ADDENDUM

No. 1

0000 MO MMO T0021 01C 000-MMO-0(216)T OATMAN – TOPOCK HIGHWAY (OLD US 66) SACRAMENTO WASH

DWG NO.S-1.08

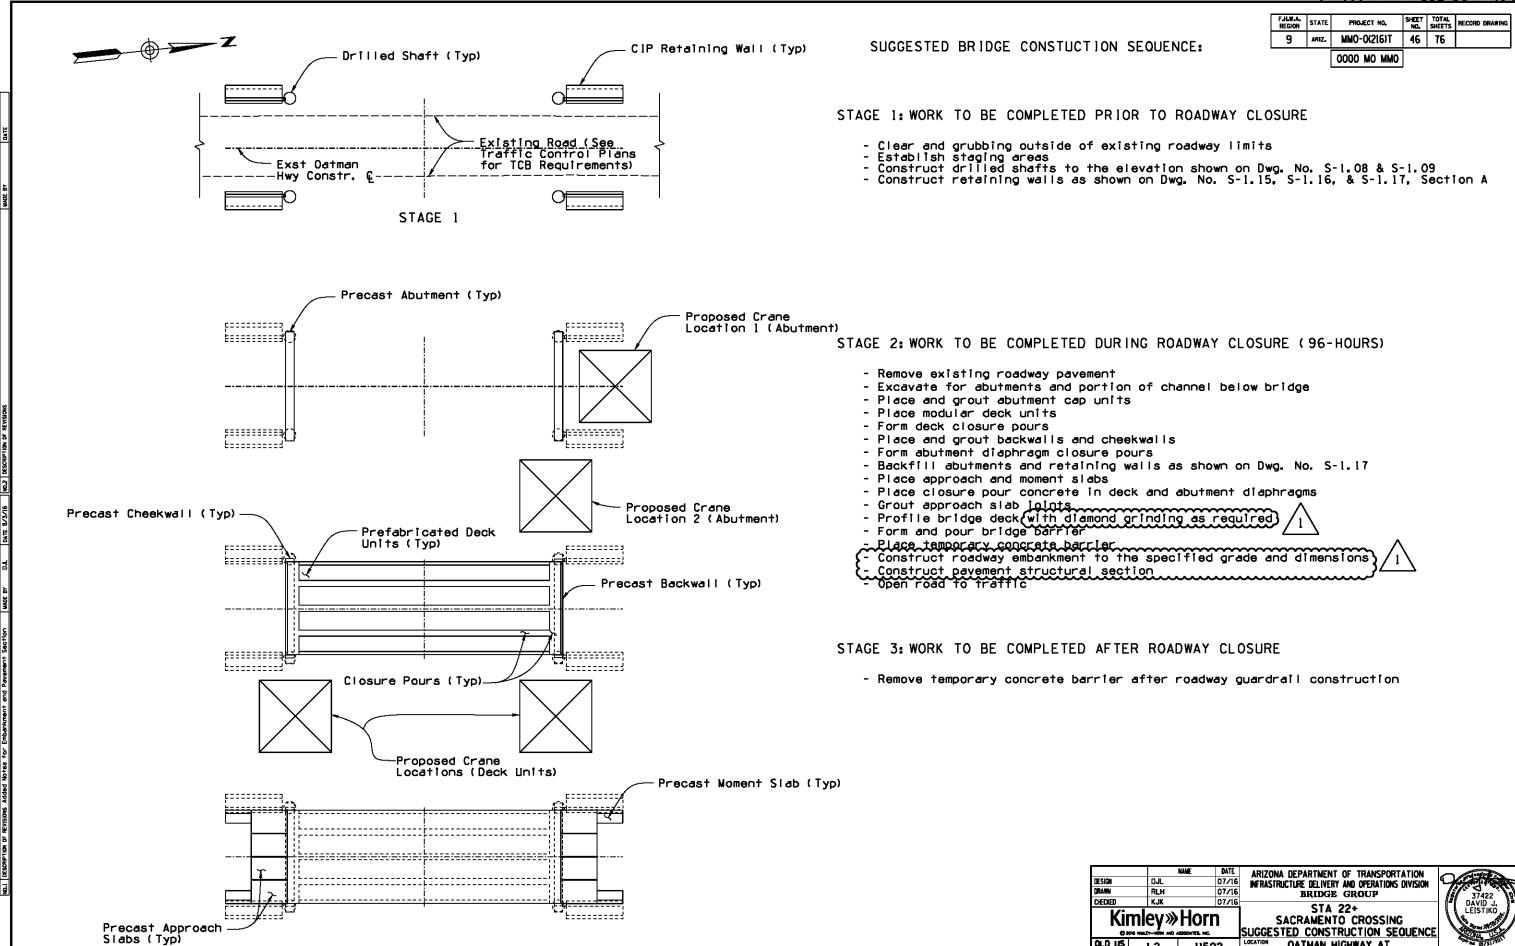
Attached is revised plan sheet 46 of 76 of the project plans. Replace the existing plan sheet 46 of 76 of the project plans with the attached revised plan sheet, and be guided accordingly.
